Maidu Bike Park Project

SCH# 2017062005

***Responses to Comments
Received on Draft Environmental
Assessment / Initial Study***

**MAIDU BIKE PARK
RESPONSES TO COMMENTS**

Revised Site Plan - Cover Sheet

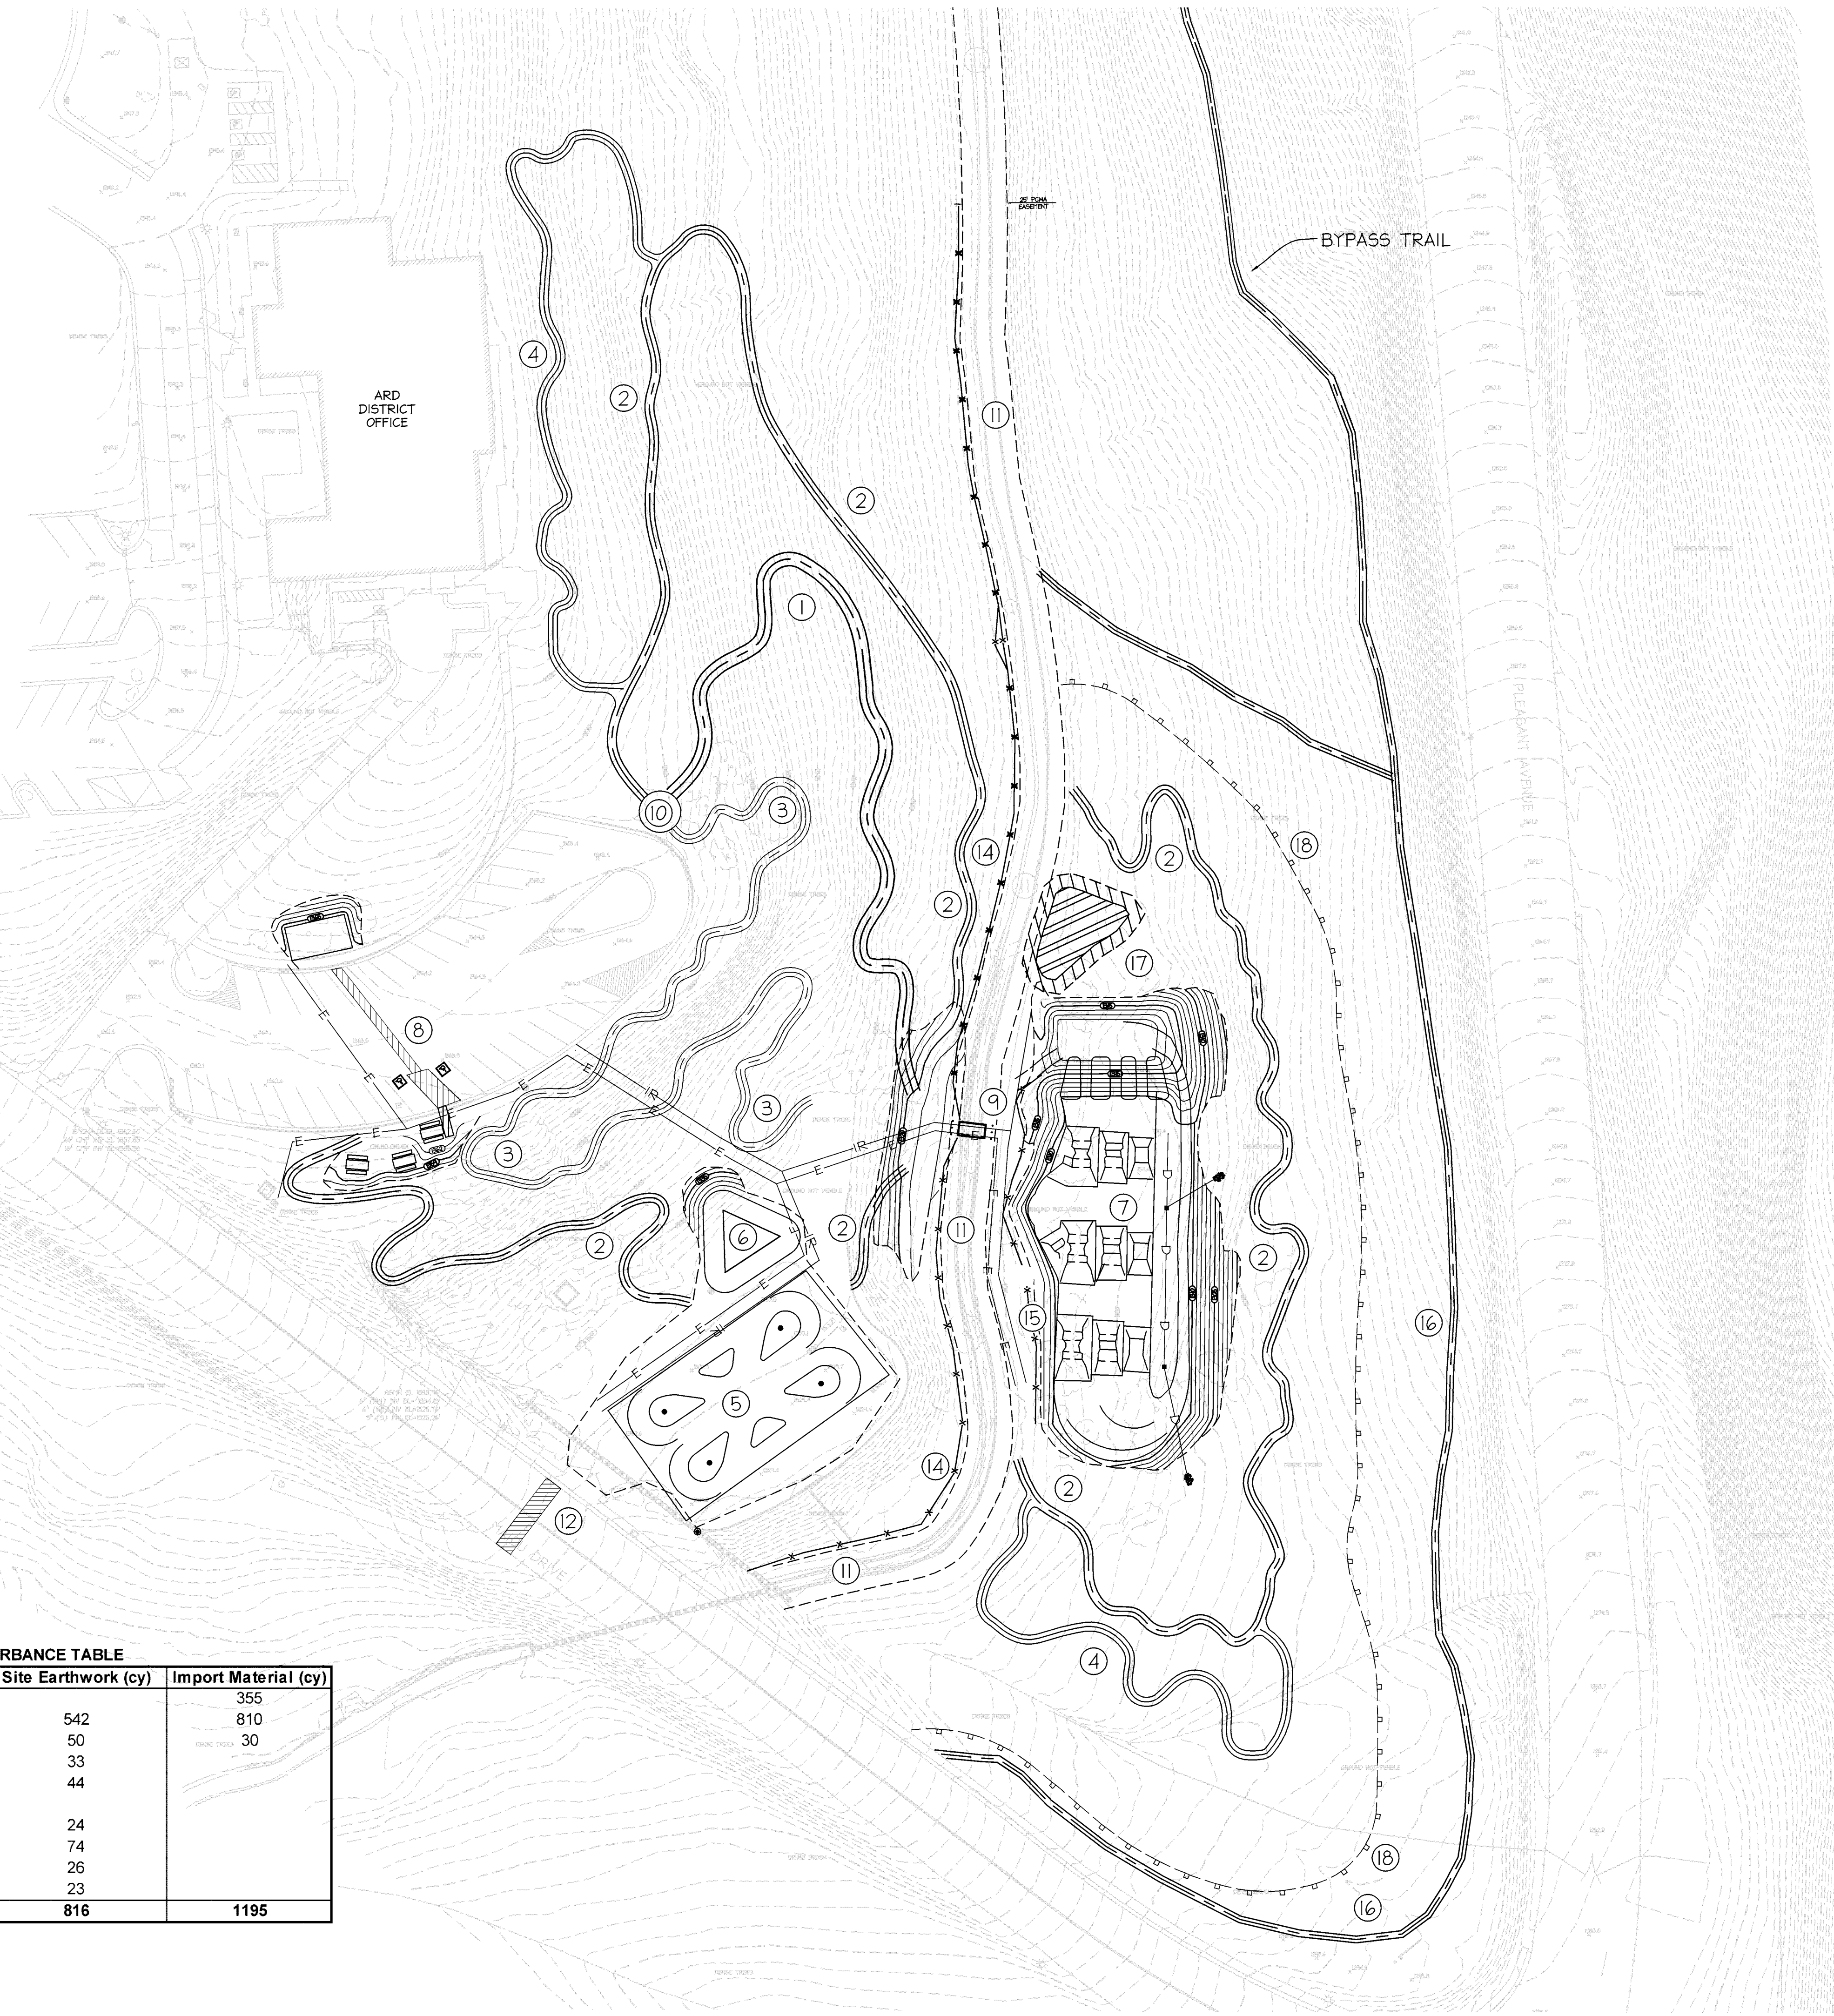
Commenters state that the proposed bike park bypass trail is planned too close to the skills loop trail (separated by only 1.5-6.3 feet in places) and that lack of separation could result in a safety issue. It is suggested that the southern portion of the skills loop trail be eliminated from the proposed site plan to provide greater trail separation.

The proposed site plan has been revised to eliminate the southern-most portion of the skills loop to provide over 40 feet of separation between the skills loop and the bypass trail. A skills section has been added to the proposed site plan just east of the Canyon View Community Center to provide similar features to the portion of trail that was eliminated near the bypass trail. Please refer to the revised site plan cover sheet included as Attachment B.
